### APPEAL SUMMARY

**Appeal ID:** 20204

**Project Address:** 2121 NE Broadway St

**Building/Business Name:** Twisted Croissant

# Exhibit 'B'

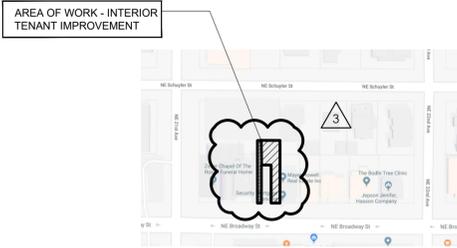
**Code Section** OSSC 1027.5

**Requires** OSSC 1027.5, "Access To A Public Way." specifically states that "The exit discharge shall provide a direct and unobstructed access to a public way"

**Proposed Design** We propose a legal easement located between subject property and the adjoining property to the West. This easement will provide safe, direct, and unobstructed access to NE Broadway to the South. See attached survey and legal description.

**Reason for alternative** This easement is needed to provide direct access to a public way from the required second exit from the building. This building is existing, as is this rear door. Due to this rear door opening over the property line, an easement is needed so that this second exit is code compliant.

**Access to Public Way with egress across property line with egress access easement: Hold for additional information.**
